**Re: SAD 228 Lot 7 Block 10
6509 Petirrojo NW
Request for Permanent C.O. - Accepted
Engineer's Stamp dated: 12-14-18 (D10D003P7)
Certification dated: 8-23-19**

**RE: SAD 228, Lot 7 Block 10
6509 Petirrojo Rd. NW
Grading and Drainage Plan
Engineers Stamp Date 12/8/14 (D10-D003P7)**

**RE: 6509 Petirrojo Rd. NW
Grading and Drainage Plan
Engineers Stamp Date 11/29/14 (D10-D003P7)**

GRADING AND DRAINAGE PLAN
LOT 7, BLOCK 10, UNIT 18, VCS
ADDRESS: 6509 PETIRROJO RD, NW

**LOT 7, BLOCK 10, UNIT 18 VCS
 6509 PETIRROJO ROAD, NW
 GRADING PLAN**

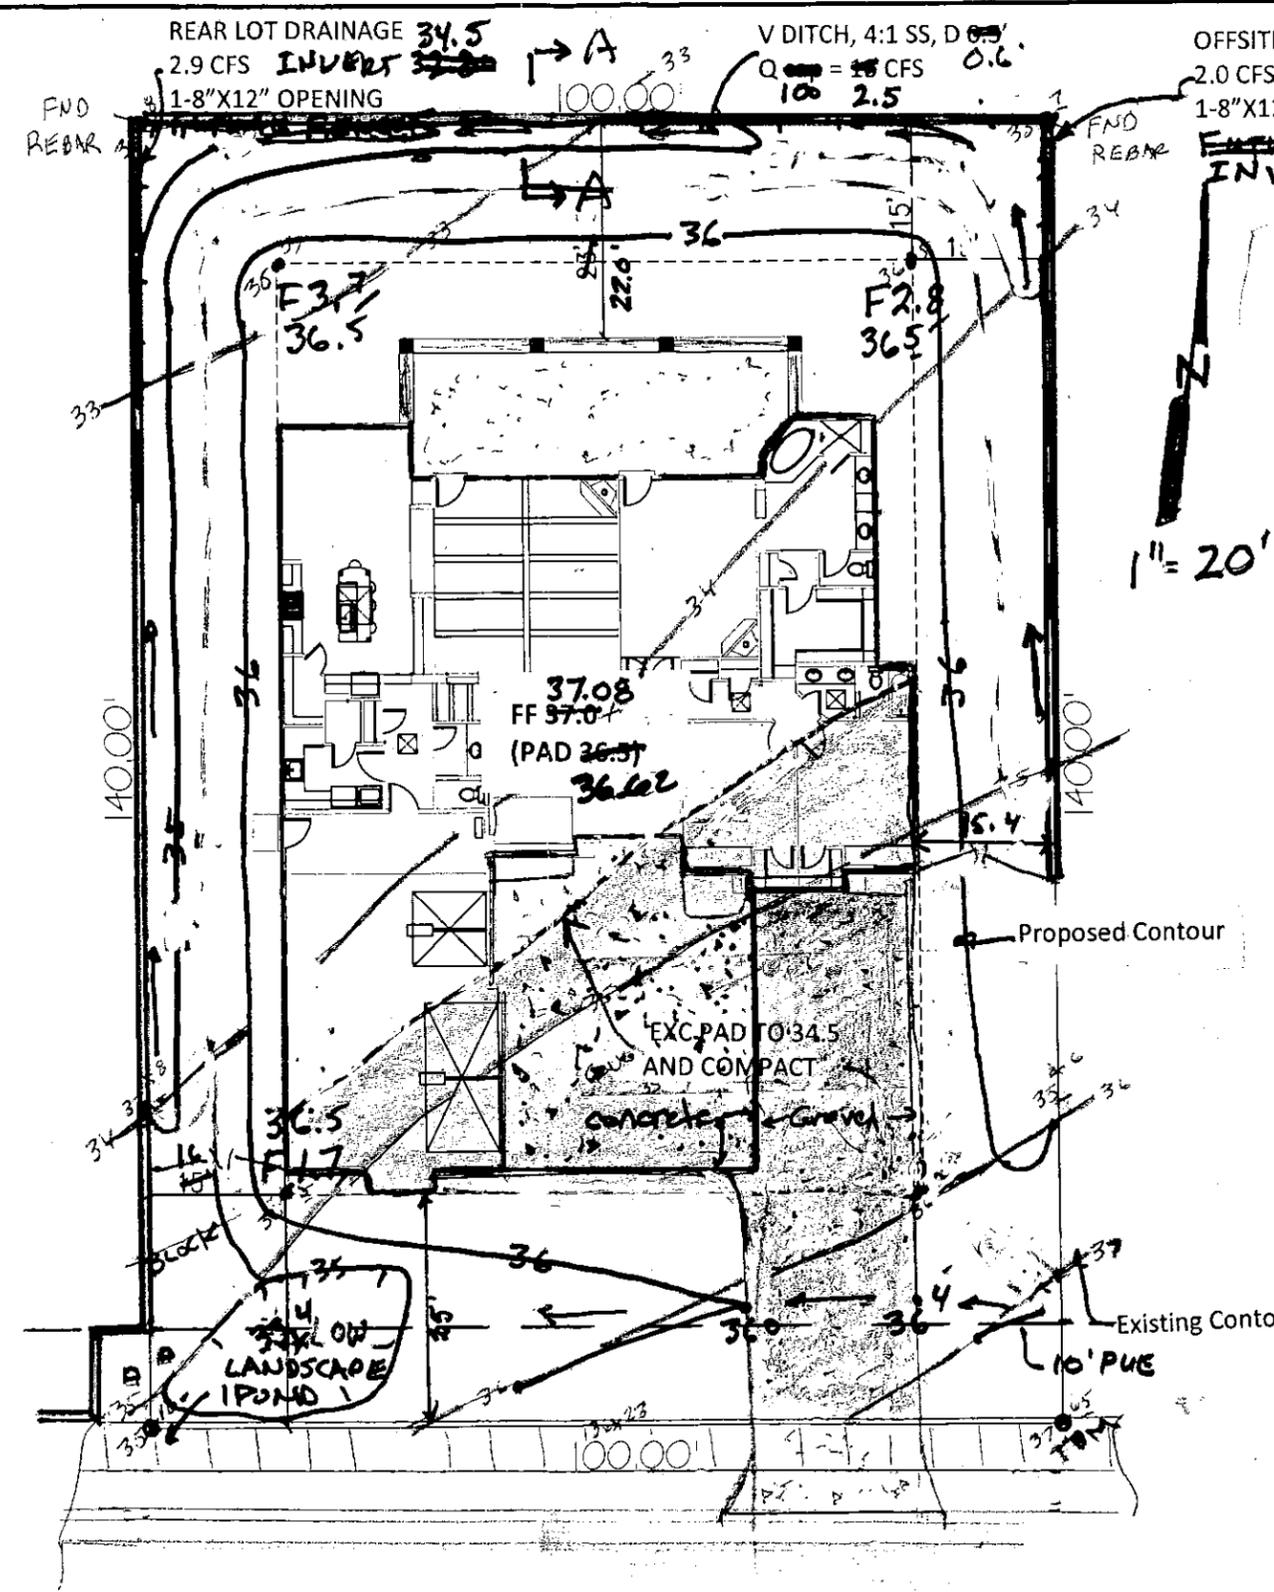
Based upon the information provided in your submittal received 12/1/2014, the above referenced Grading and Drainage Plan cannot be approved for Grading Permit or Building Permit until the following comments are addressed.

- Provide a Vicinity map, a FEMA map or designation, a narrative.
- Mention of the first flush per EPA standards is required. The amount required is .34" times the impervious area.
- Provide a section of the V Ditch and calculations for the ditch. 13.0cfs seems a bit too much. Is the ditch a shared ditch, if so where will the block fence be placed?
- What are the inverts of the openings? Is this a block fence?
- What is the flow line in the street?

V-DITCH SECTION A-A

Mannings EQ: $Q = 1.49/n \cdot A \cdot R^{2/3} \cdot S^{1/2}$

$D = 0.6'$ $S = 0.90\%$ $n = 0.03$
 $Q_{100} = 2.5 \text{ cfs}$ $V_{100} = 1.7 \text{ fps}$

Narrative

First Flush per EPA Standards

The Initial First Flush to be managed is 0.44" less 0.10" initial impervious abstraction = 0.34" or 480 cubic feet. The initial storage on site will be collected and held in the two landscape ponds near the street as shown on the Plan.

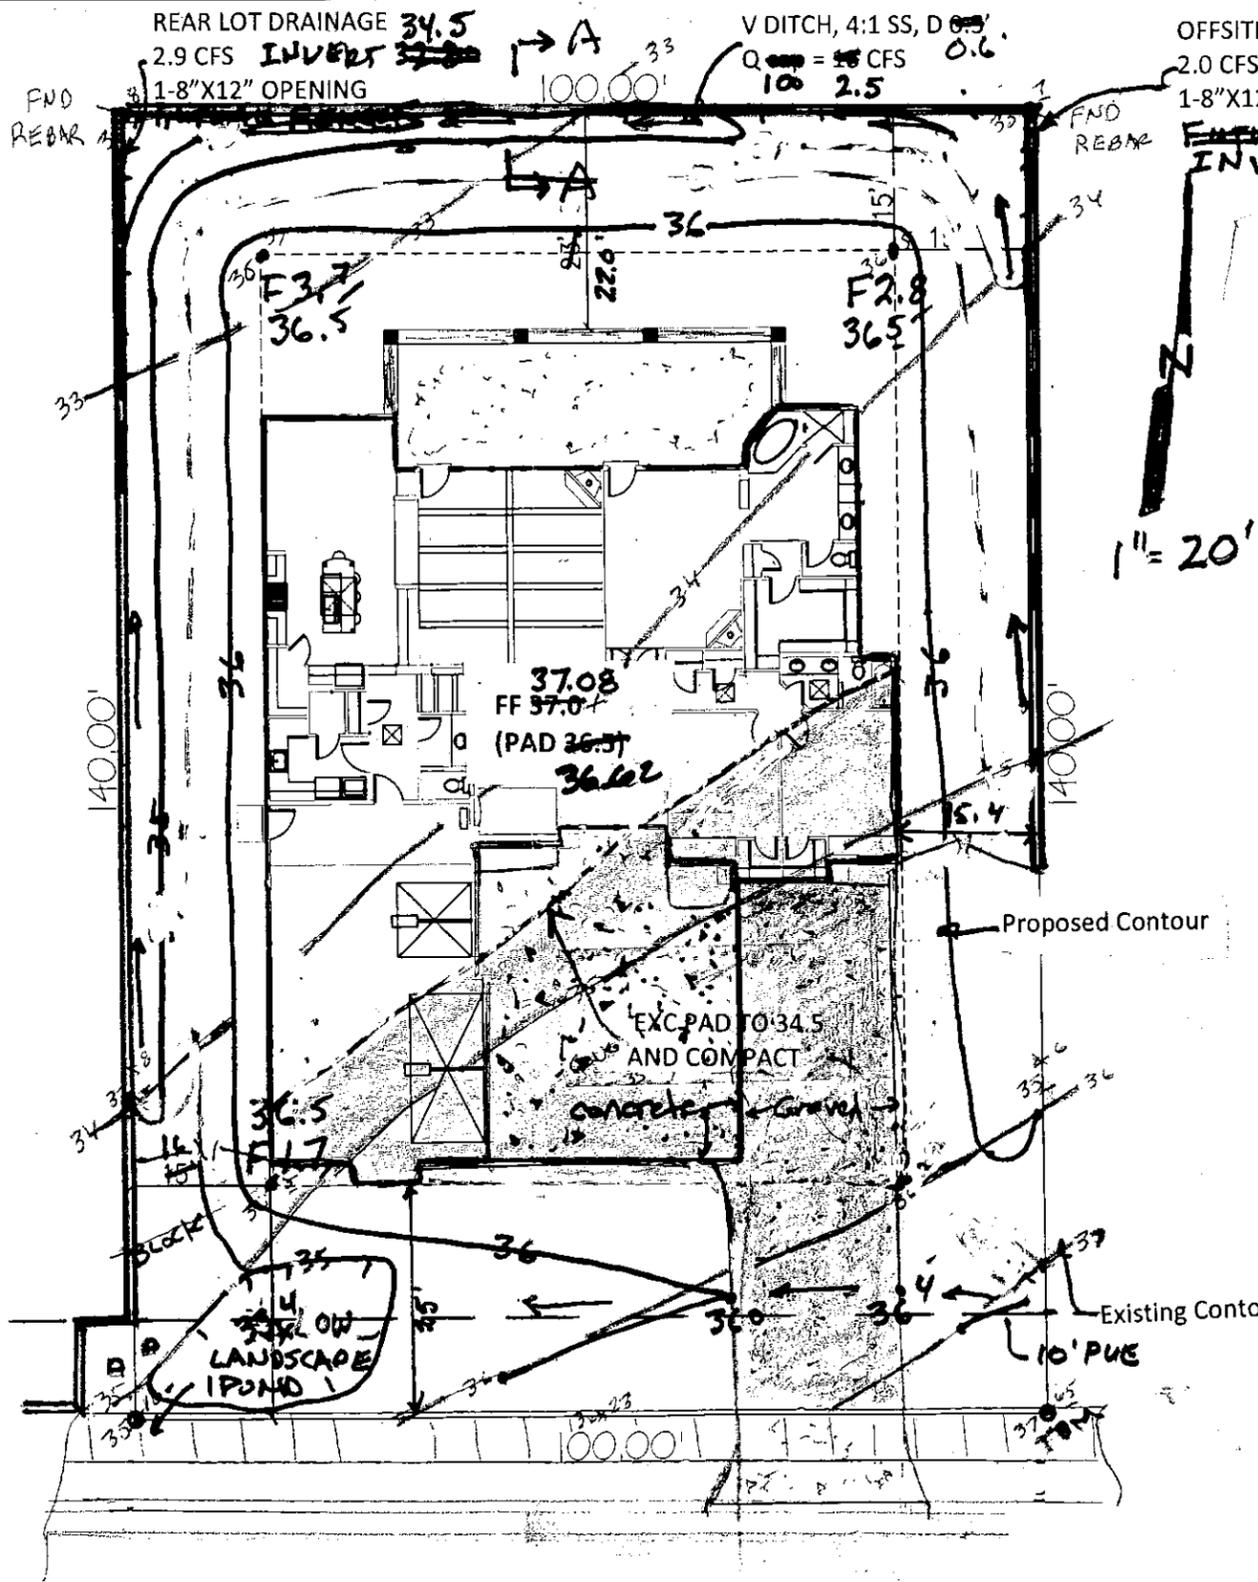
Based on the Certification received 8/23/2019, this residence is acceptable for release of Certificate of Occupancy by Hydrology.

Please advise the home owner that all ponds are to remain in place and kept maintained, not allowing dirt or debris to enter the public right of way or ponds. This is according to the SAD 228 covenants and agreements with the City of Albuquerque.
